To: General Contractors
From: Greg Shinberg, Project Manager
Re: 645 Congress Addendum # 2
Date: June 16, 2009

A-S Addendum 02

To: **Bidding General Contractors** and Registered Plan Holders
From: Ben Walter, CWS Architects
Project: **Renovations to 645 Congress Street** – Portland, Maine
Subject: **A-S Addendum 02**

12'-0" = 1'-0"
 UNIT 207 Kitchen 5/26/09
 TPT

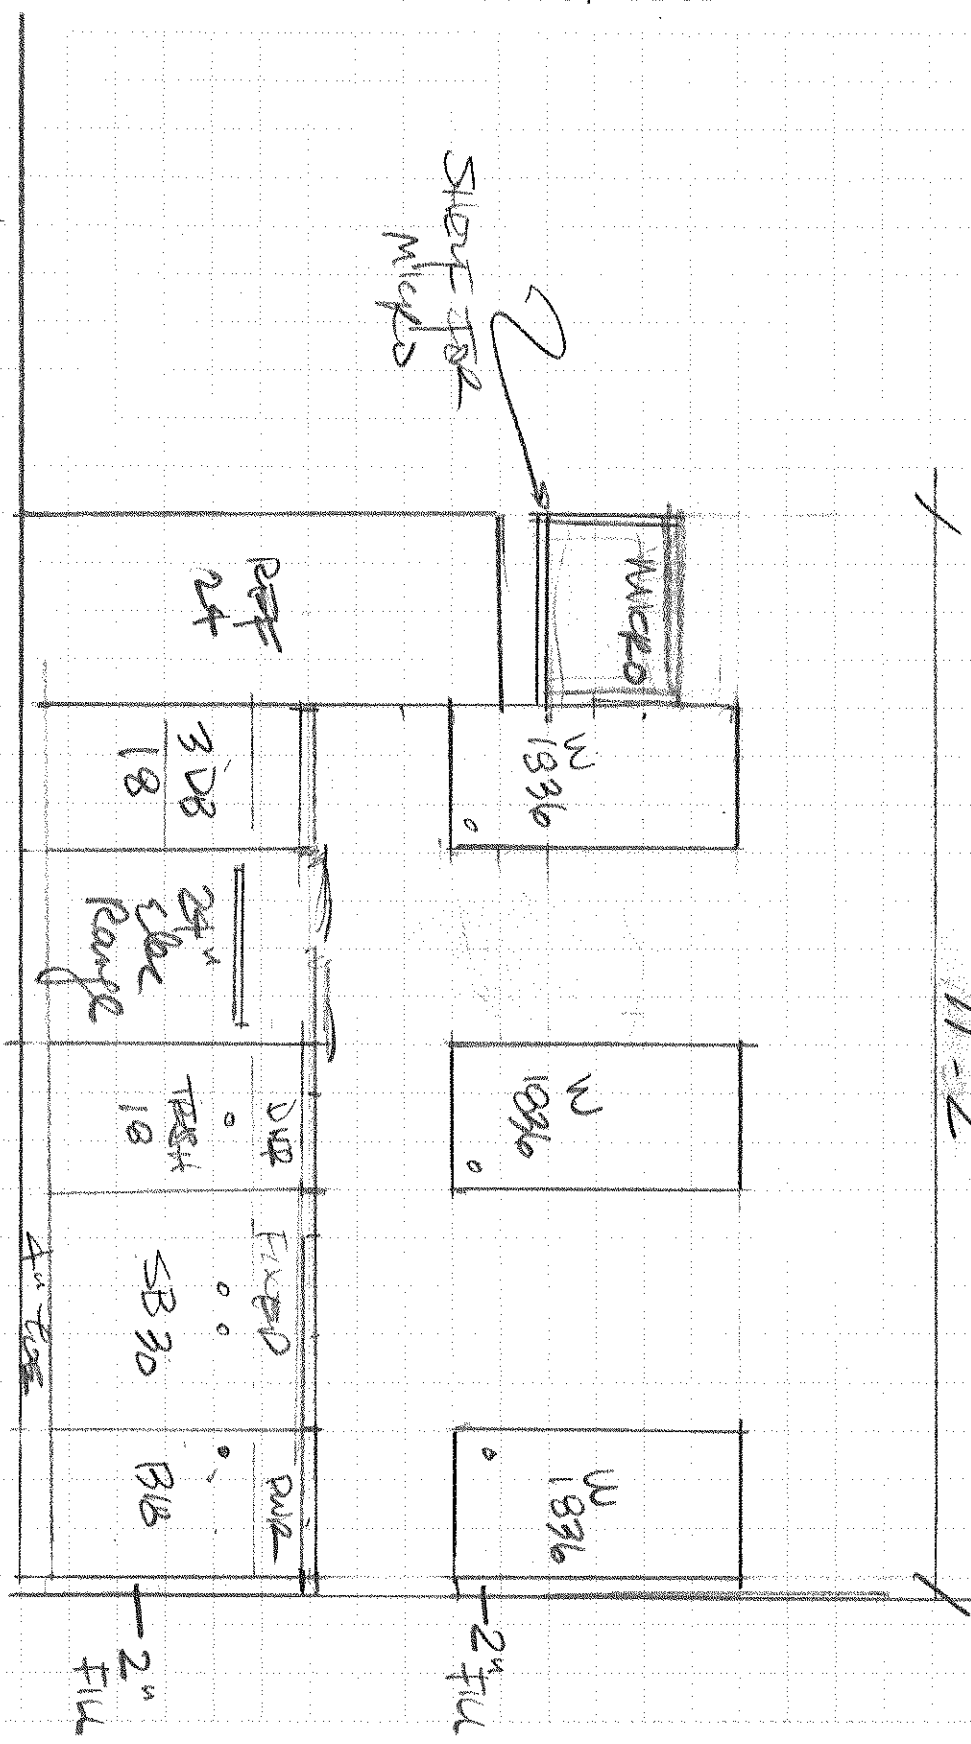
2. Provide a unit price for the kitchen as a unit price as noted in SCSK-1; All kitchens are noted in the A drawings. This is a typical kitchen design;

3. All Appliances by Owner; Dishwasher connection and final installation by GC; No water feed installed for ref;
4. Note that Sheets F1.00 to F1.06 show the location and type of all ceilings. Existing ceilings to remain where no new ceiling is noted;

SKA-1.11

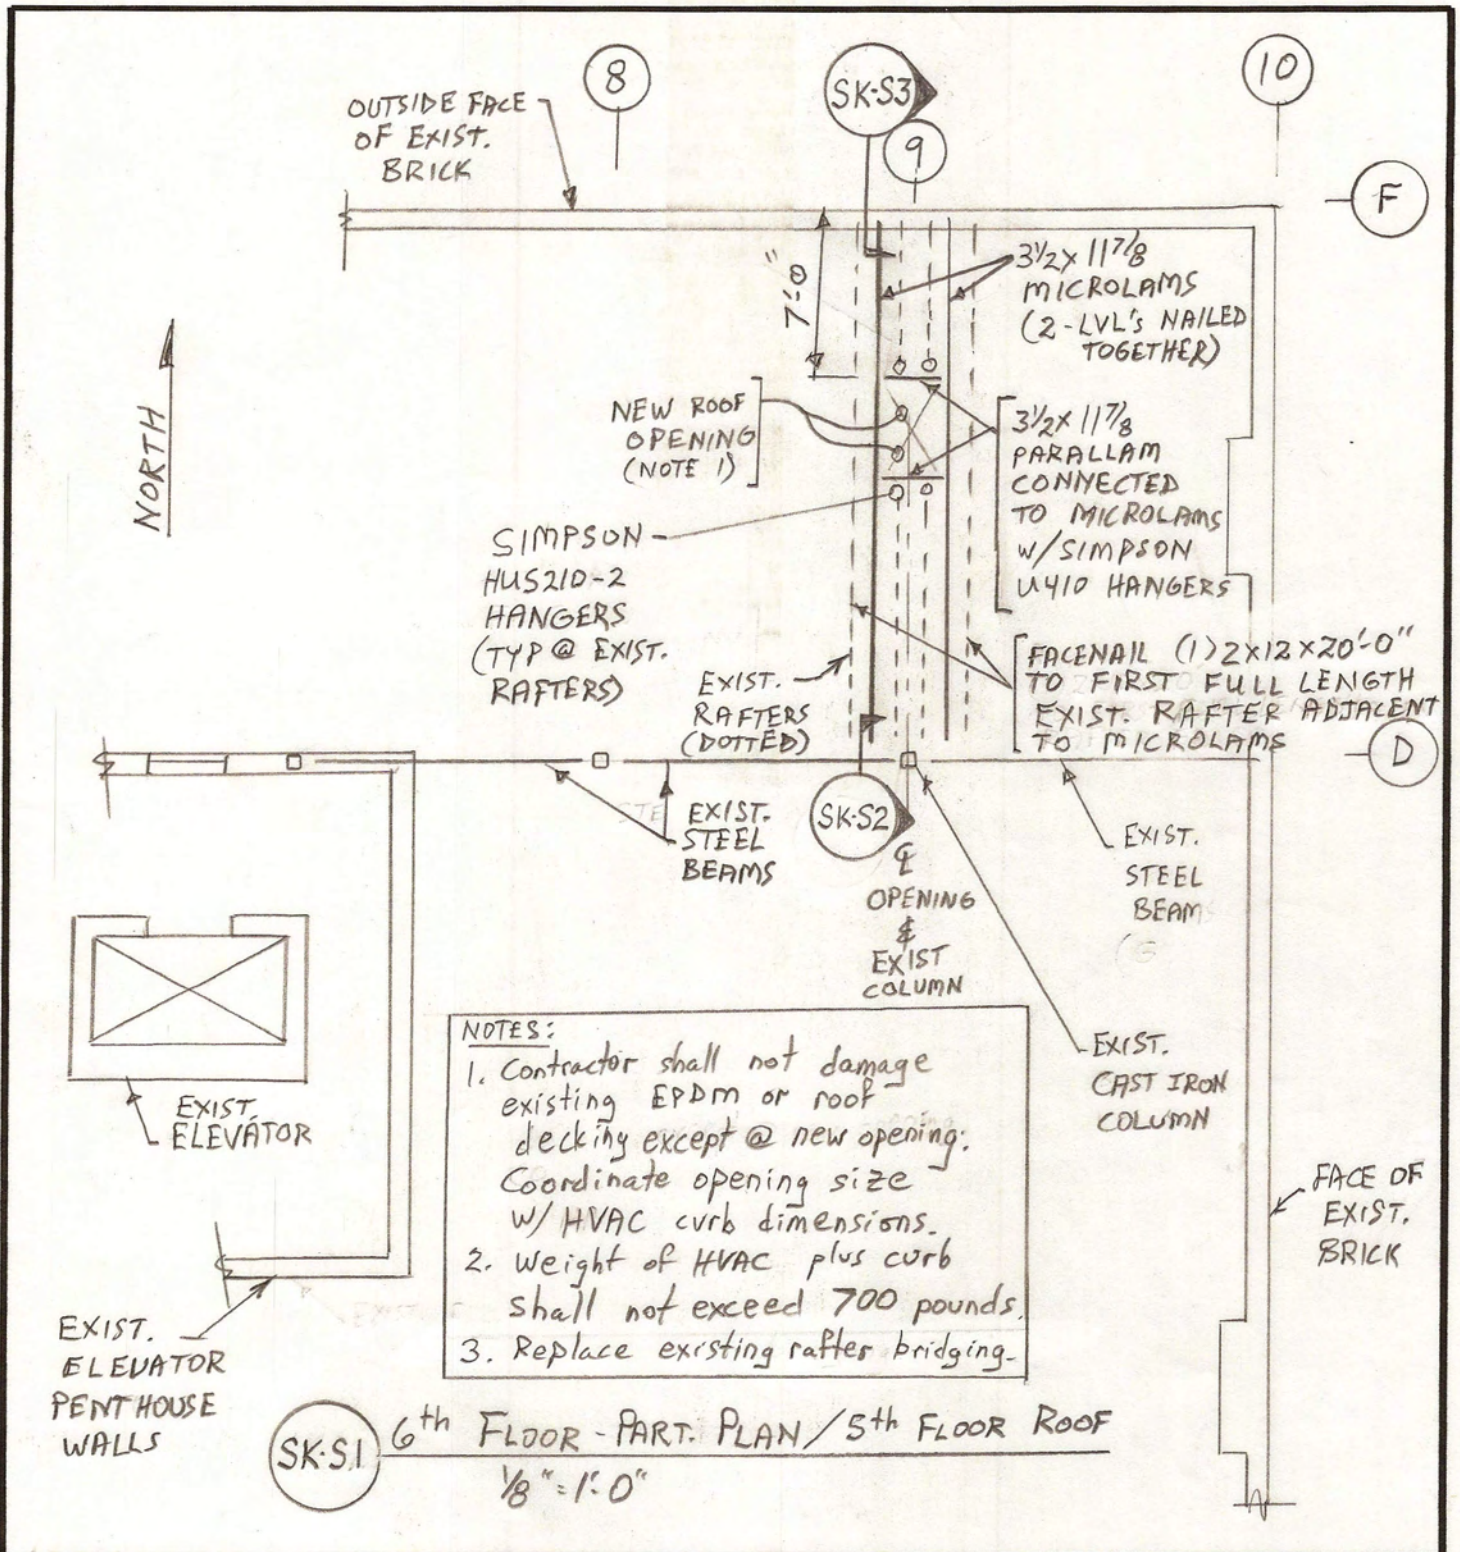
<u>SKA No.</u>	<u>Affects</u>	<u>Description of Change</u>
a. SKA-1.11	A4.01	EXISTING AND NEW RATINGS COMMON WALLS AND FLOOR CEILINGS

7. Required Fire Ratings Clarification – SKA-1.11 dated 6/8/2009 was issued in Addendum 01 and was intended to clarify both the existing and required ratings of floor and wall assemblies. Refer

to the Drawing A0.01 Assemblies Schedule for reference floor and wall assemblies. Where as many of the rated assemblies (mostly ceilings) are concealed, Contractors should assume that the assemblies listed with existing components are intact and that new components listed in the assemblies shall be provided by the Contractor. Where penetrations or modifications are made through or to existing assemblies, repair and/or replace assemblies using listed materials or Firestopping systems specified. Note assemblies EF1 and EF2 issued in Addendum 01. Where indicated (1st and 2nd Floor Ceilings), remove existing ceilings and reconstruct the assemblies to meet the requirements of EF1 and EF2.

SK-S1

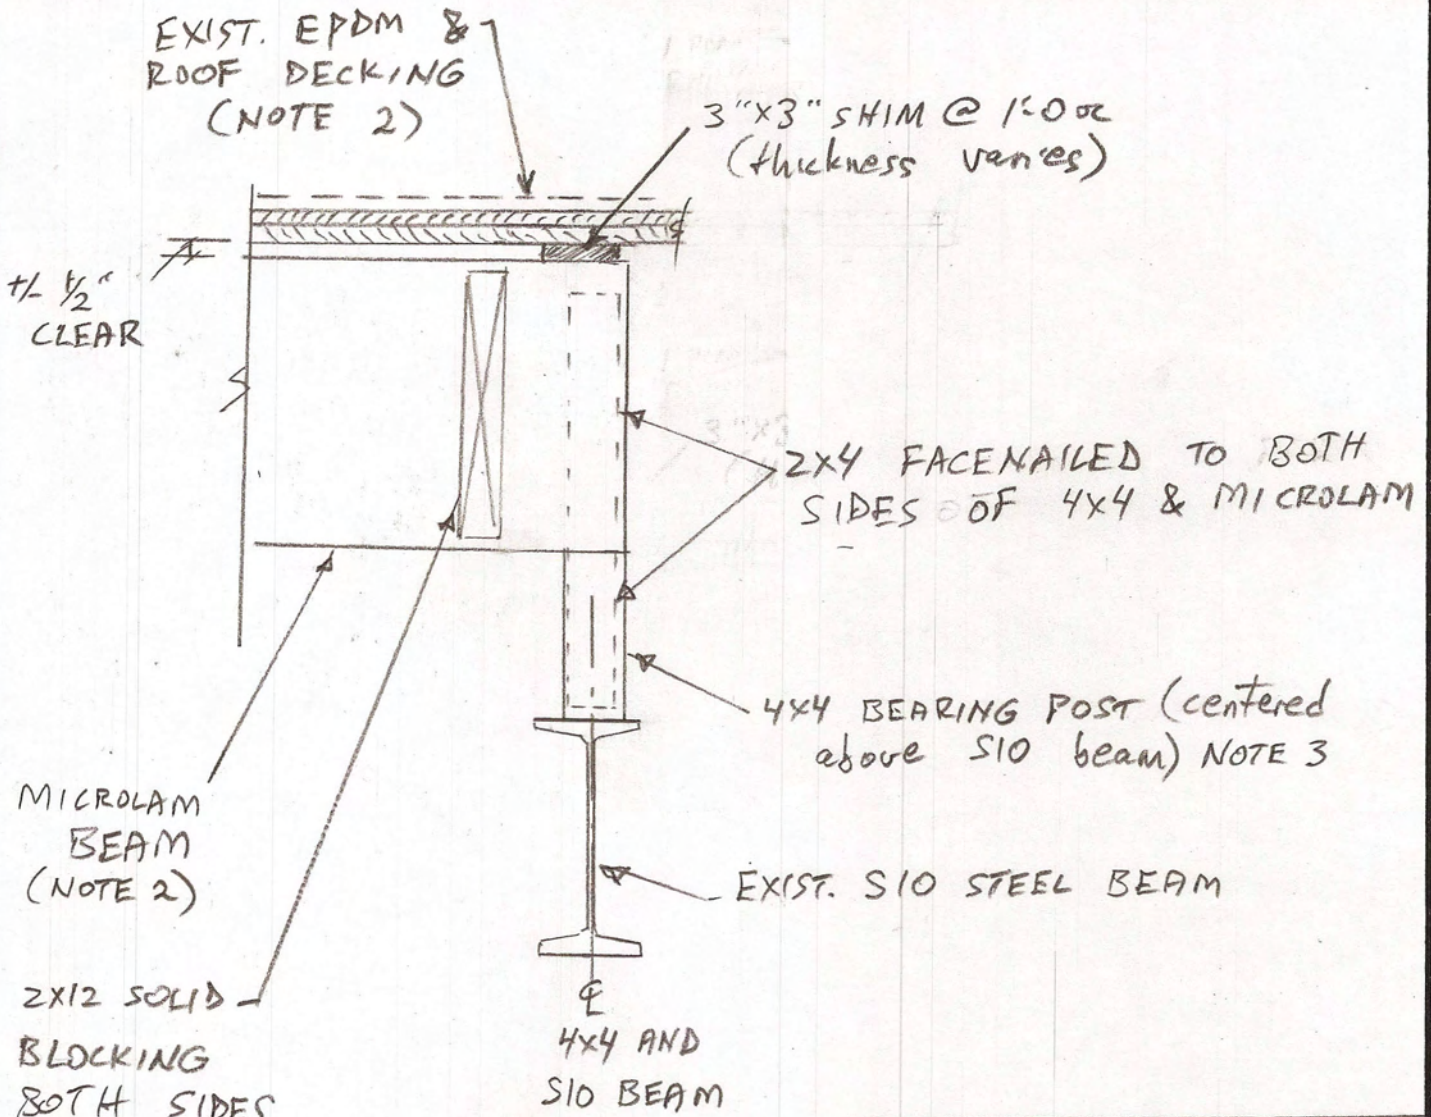
3. On **Drawing S5.7**, add rooftop HVAC framing support modifications as specified on the attached sketches SK-S1, SK-S2 and SK-S3.
4. Provide **alternate pricing** for future rooftop steel framing chiller supports as specified on attached sketches SK-S4, SK-S5, SK-S6, SK-S7, SK-S8, and SK-S9. See item 1 above.

- NOTES:
1. Contractor shall not damage existing EPDM or roof decking except @ new opening. Coordinate opening size w/ HVAC curb dimensions.
 2. Weight of HVAC plus curb shall not exceed 700 pounds.
 3. Replace existing rafter bridging.

REVISIONS TO S2.1 FOUNDATIONS

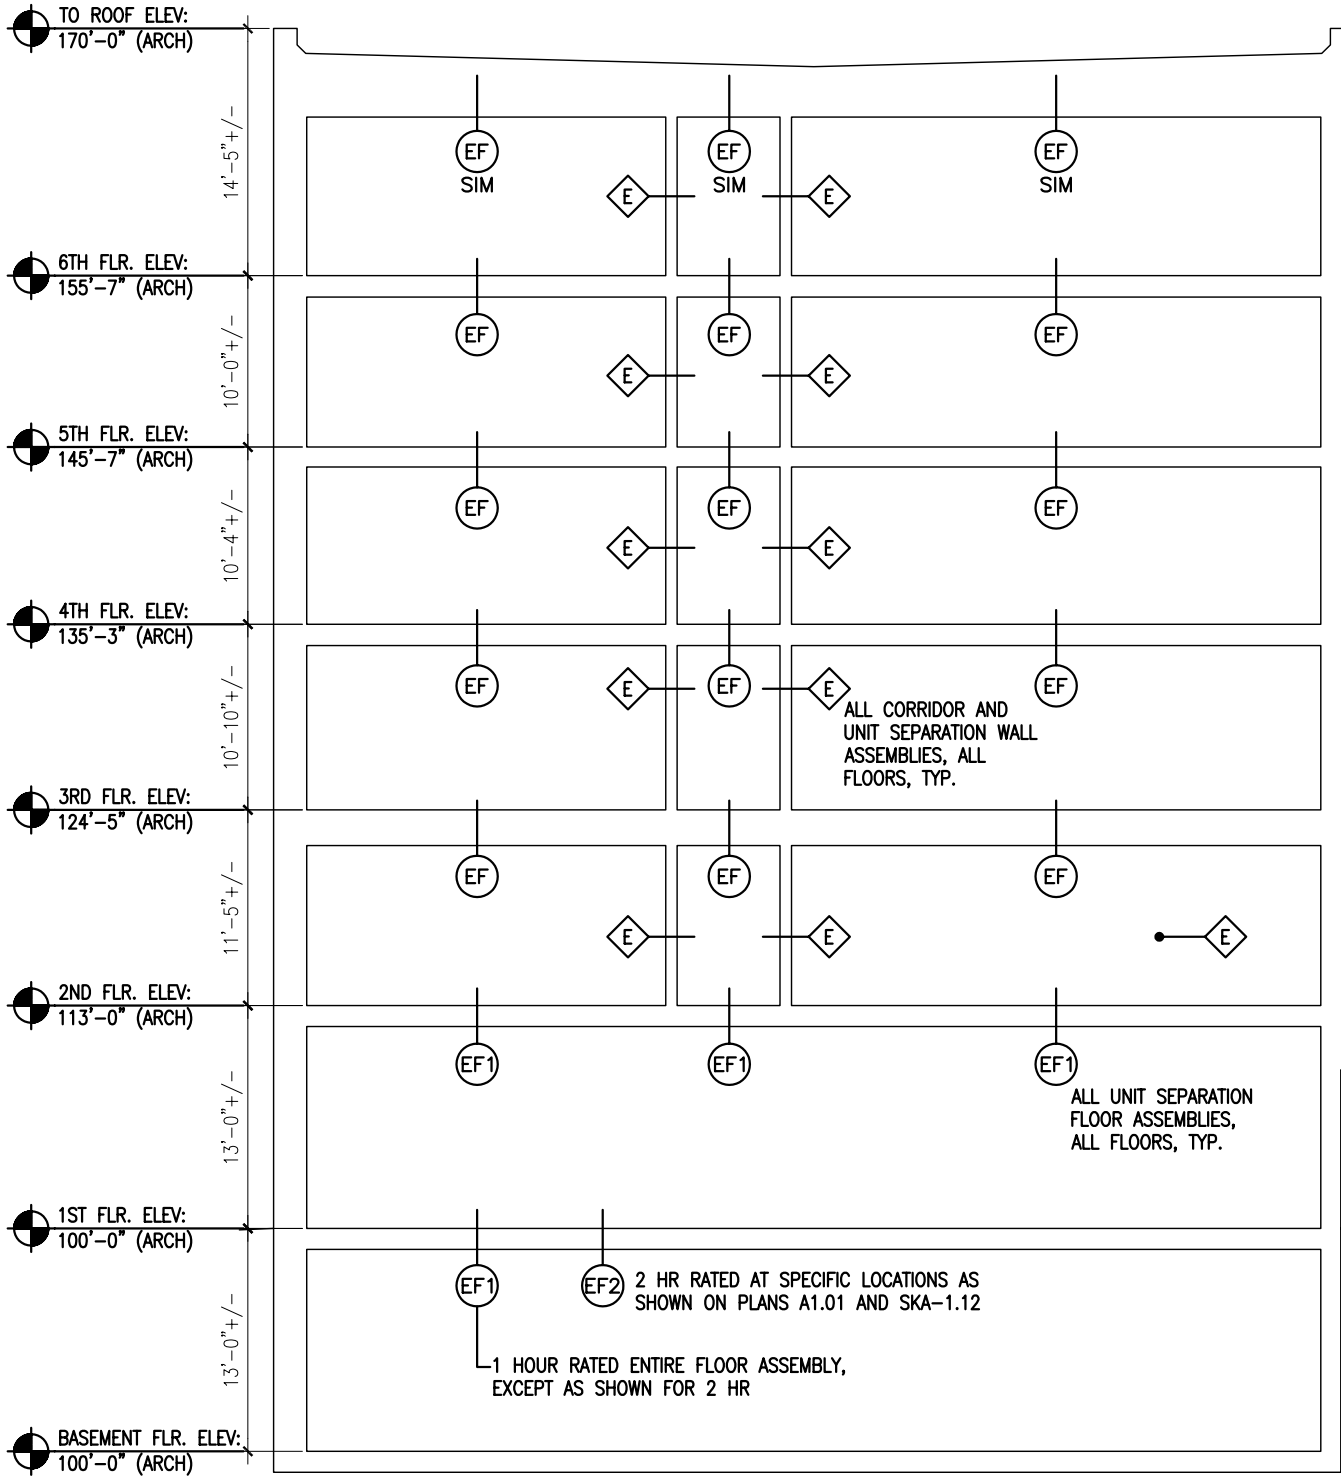
5. On **Drawing S2.1, Plan H1/S2.1** - Revise Plan H1 as specified on attached sketch SK-S10 (changes shown clouded).
